Re: Based on Expert Review, Recommendation to the Michigan Petroleum Pipeline Task Force that Enbridge's Line 5 in the Straits Be Shut Down and/or Stringent Measures Be Imposed Pending a Comprehensive Review by the State under Public Trust Law to Assess Alternatives that Prevent Catastrophic Harm to Our Public Trust Waters of The Great Lakes

**A COMPOSITE SUMMARY OF EXPERT COMMENT, FINDINGS, AND OPINIONS ON
ENBRIDGE’S LINE 5 OIL PIPELINE IN THE STRAITS OF MACKINAC IN LAKE MICHIGAN**

Compiled by James Olson, J.D., LL.M. and Liz Kirkwood, J.D.

Figure 2. Safety Factor Based on Yield Strength with a Weld Efficiency Factor of 1.0 as a Function of Support Spacing at 600 psig Maximum Allowed Pressure at 290 Feet Underwater.

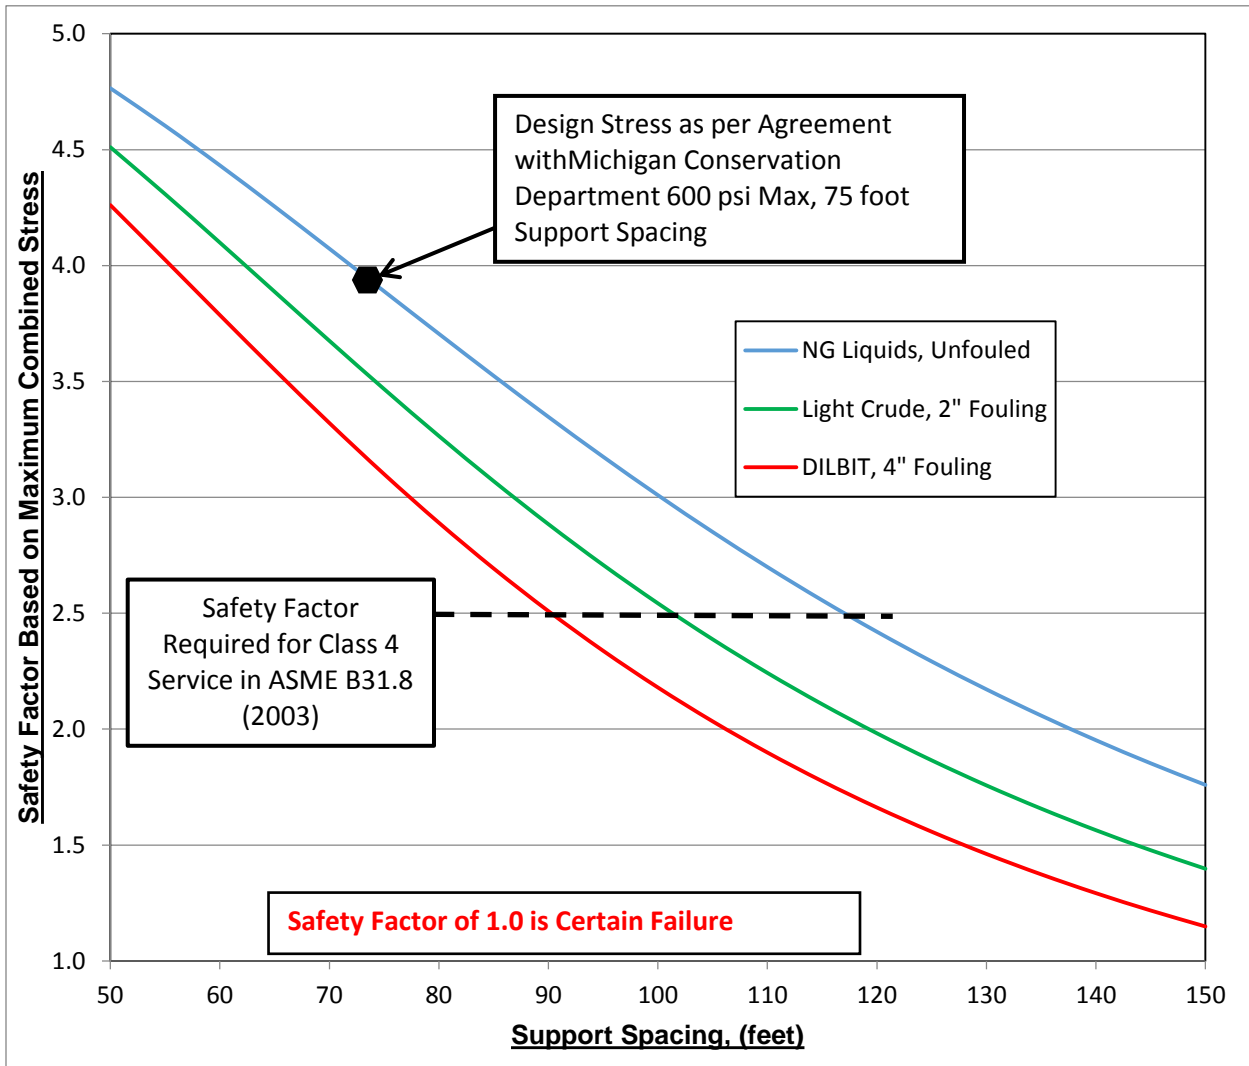
stresses in the changing aquatic environment and use since that time for transport of natural gas (NG) liquids (unfouled), light crude (2-inch fouling), heavy oil such as dilbit⁹ (4-inch fouling), it can be concluded that: the margin of safety in 1953 for NG liquid through Line 5 would have a factor of 3.9; the margin of safety for light crude would have a factor of 3.4, and heavy oil or dilbit a factor of 2.75.¹⁰ The safety factor required for the pipeline under ASME B31.8 (2003) is 2.5. At a safety factor of 1.0, there would be certain failure.

The only public information on the design in 1953 of Line 5 is summarized in “Enbridge Energy Limited Partners, Operational Reliability Plan, Line 5 and Mackinac Straits Crossing.” This is not an engineering report, but appears to be a set of talking points to justify the safety of Line 5 to the Task Force and public. The document states that stress corrosion cracking “requires both a corrosive environment and high stress.” “However, neither element is present in the pipelines through the Straits, which have excellent coating at less than 25% of their design capacity.” This can be interpreted to mean that when operated at 600 psig and no more than 75-foot spans, the combined stress on Line 5 is less than 25% of the yield stress of the pipeline assuming adequate weld efficiency. This equates to the listed safety factor of 3.9 for NG liquid listed above.¹¹

As noted above, the easement required maximum 75-foot spans. As disclosed in recent years, the maximum length of the actual spans for the pipeline under the Straits is 90 feet, which is significantly less than the specified margin of safety – only 64 percent of the required span length in the easement. More recently, Enbridge has applied for permits to install additional supports. Permits were obtained in 2014 for installation of supports every 50 feet under the GLSLA, but the DEQ did not request information related to the overall future plans, alternatives, or logistical options regarding Line 5. This should have been done so other alternatives to the old pipeline that would prevent risk to the Straits altogether.¹²
